# FINAL
# Coal Ash Impoundment - Specific Site Assessment Report PacifiCorp Energy

Jim Bridger Power Station

September 2009
Project 091330

**Photo 20: FGD Pond 2, Upstream Face Erosion and Pipe from Sump Drain Pump Back Near Station 84+00**

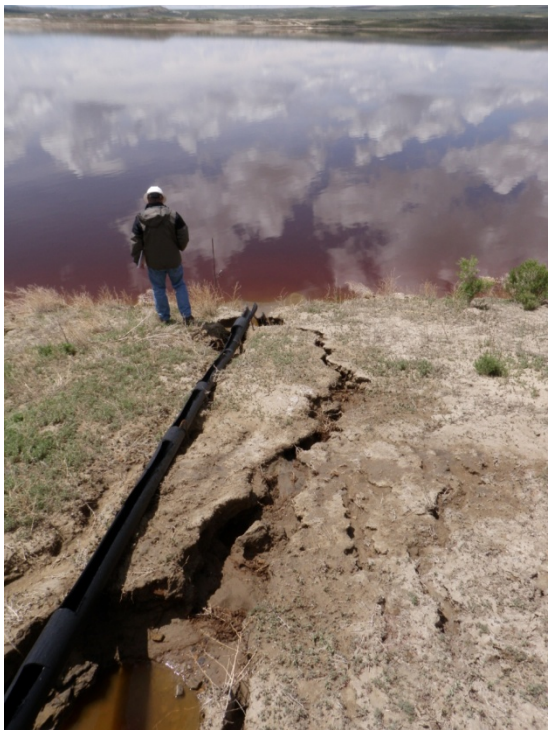
**Photo 18: FGD Pond 2, Upstream face Pipe causing erosion from Crest pipe from Sump Drain Pump Back Near Station 84+00**

**Photo 19: FGD Pond 2, Upstream Face Erosion and Pipe from Sump Drain Pump Back Near Station 84+00**

Figure E.2-2

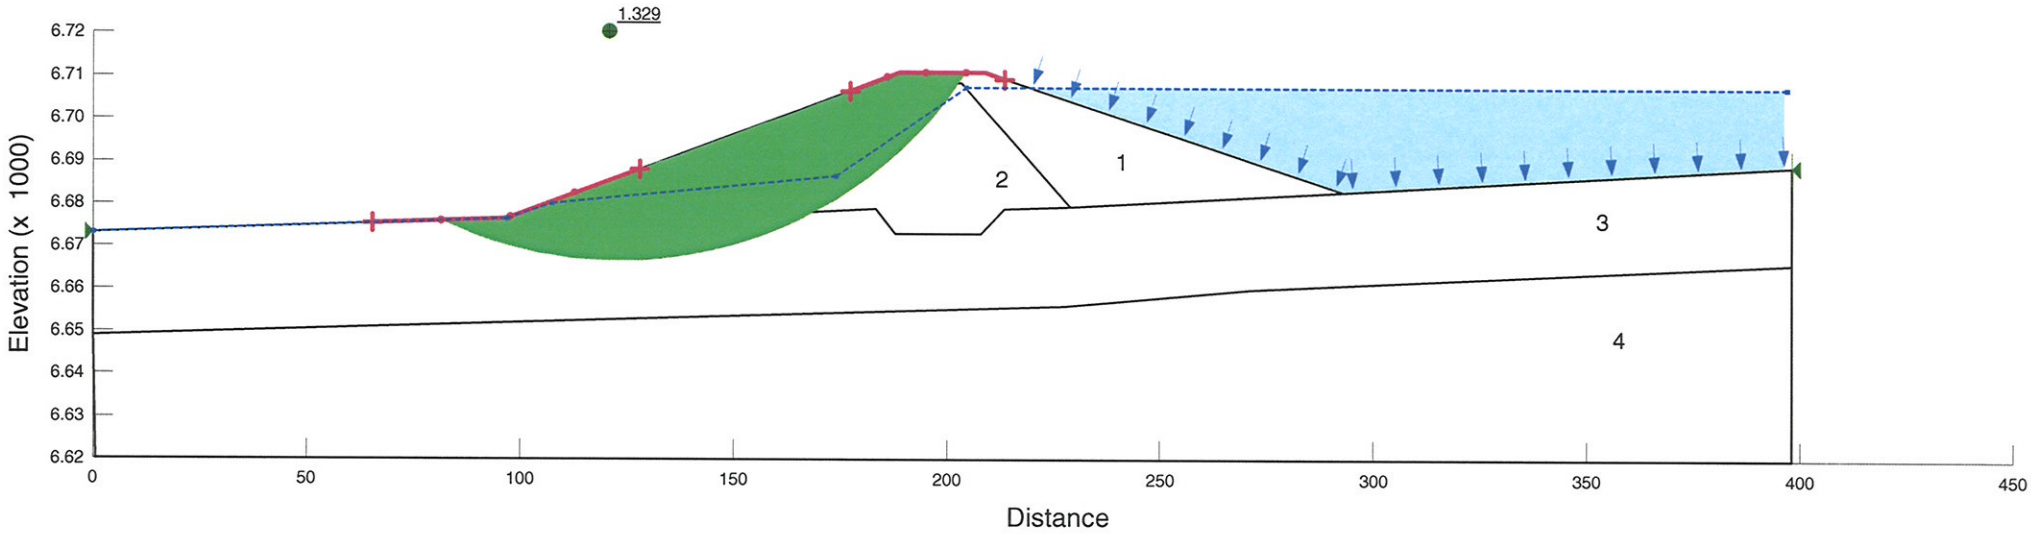
The structural stability of four of the five embankment sections evaluated for FGD Pond 2 meets or exceeds the minimum required factors of safety in accordance with FERC guidelines. Check analyses completed by GEI show the factor of safety for steady seepage conditions is 1.33 at FGD Pond 2 Station 8+00, which is below the FERC minimum required criteria of 1.5. A factor of safety of 1.33 is substantially below the required factor of safety, however it does not indicate impending instability. The check analyses performed by GEI resulted in lower calculated factors of safety for steady seepage and end of construction conditions than reported in the 2001 Design Report. It is concerning that the design stability analyses are not reproducible.

1. The calculated factor of safety at Station 8+00 of 1.33 for static steady-seepage is below the state and federal guidance of 1.5. Re-evaluate this loading condition at Station 8+00 and, if the issue cannot be resolved by analysis, implement measures to improve the stability to achieve a factor of safety of 1.5. Also, the 2001 stability results could not be reproduced in check analyses and did not address the anticipated loss of embankment due to the planned erosion of the upstream slope. Revisit and revise the 2001 stability analysis as necessary to complete the documentation of the design.
